**PRELIMINARY SAFETY AND ENVIRONMENTAL
INFORMATION DOCUMENT**

VOLUME III

**LIGHT-WATER
BREEDER REACTORS**

**NONPROLIFERATION ALTERNATIVE SYSTEMS
ASSESSMENT PROGRAM**

Figure 2-6. Typical LWBR material-flow diagram for MEU(5), Th prebreeder Shippingport type I concept.

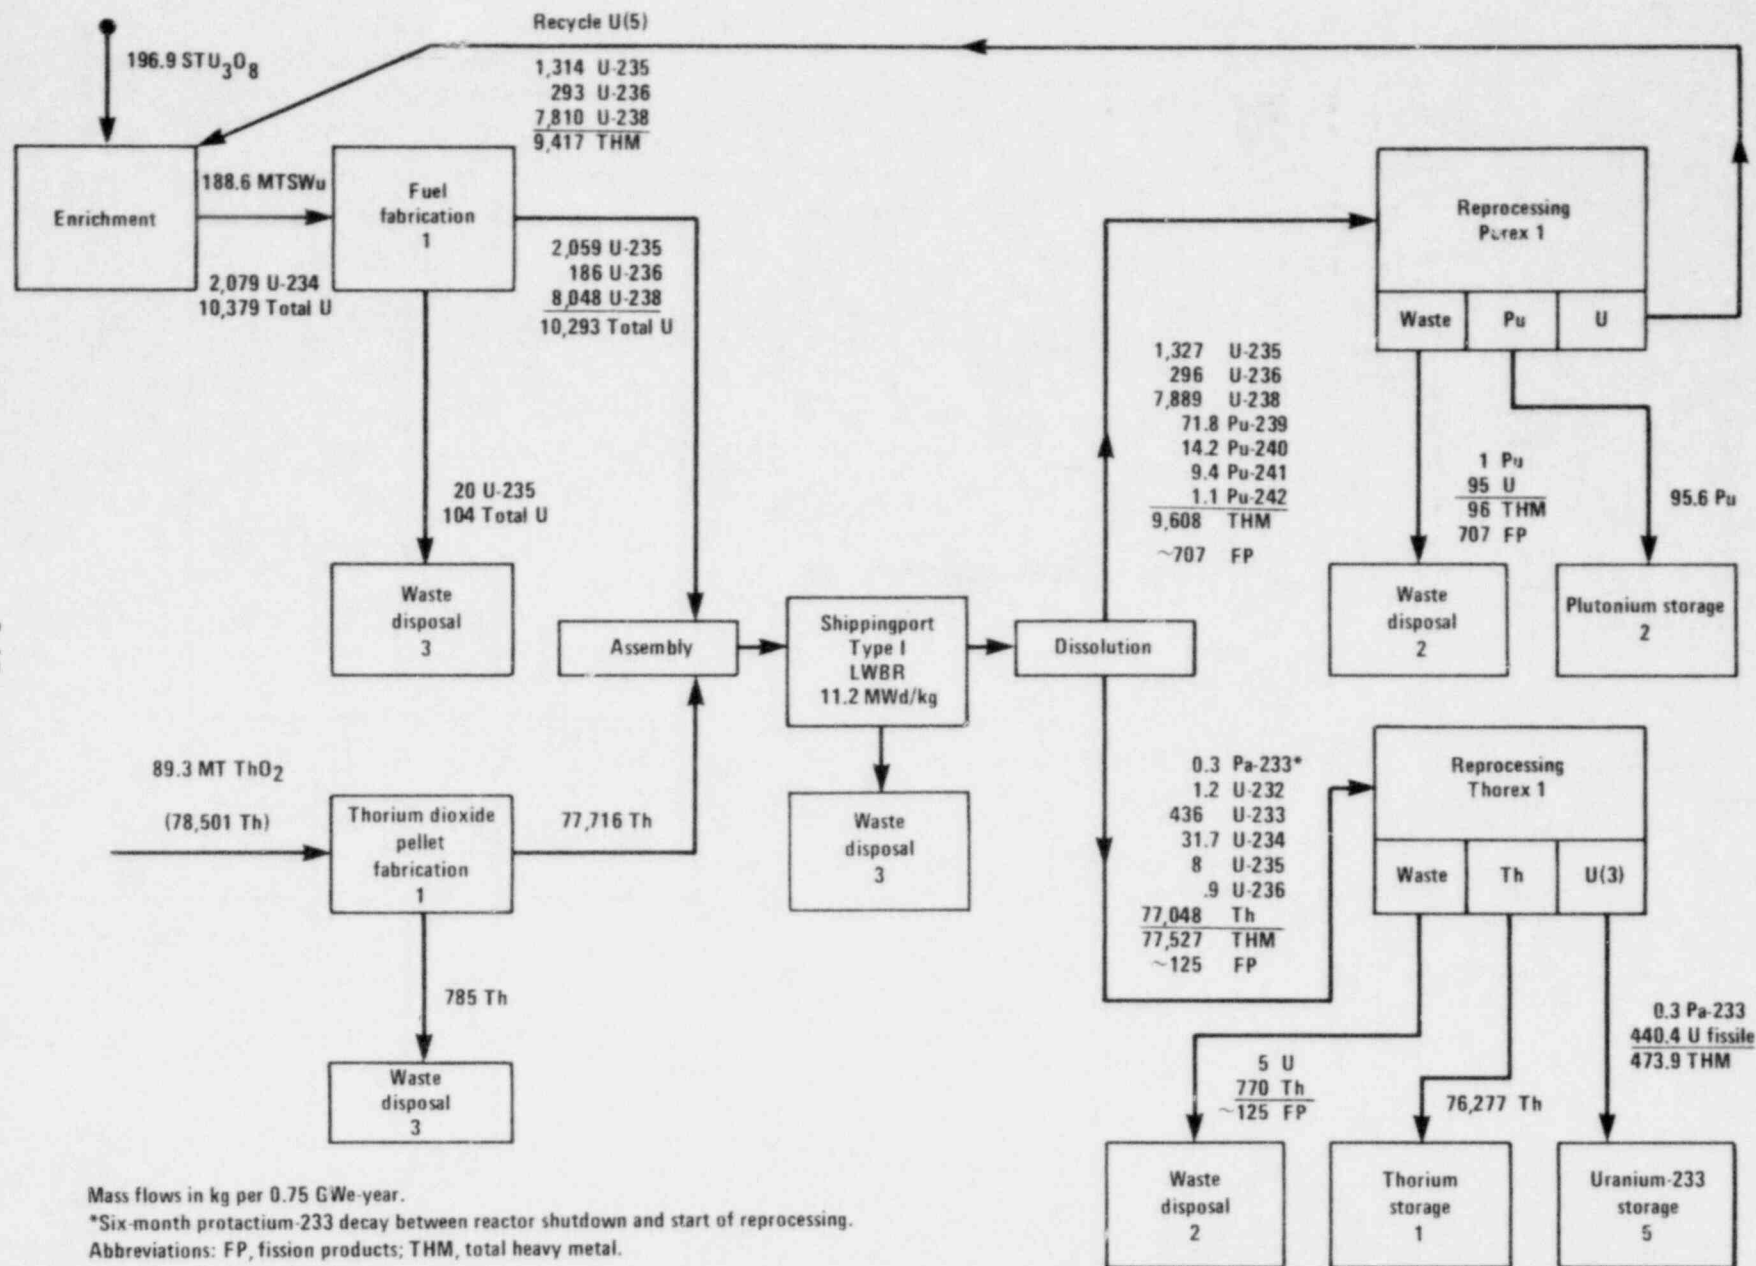
In addition, we believe that if the concept of the duplex fuel is important to the viability of the breeder concept, additional information must be provided in Volume III or Volume VII concerning the development status of the disassembly operation shown in Figure 2-6.
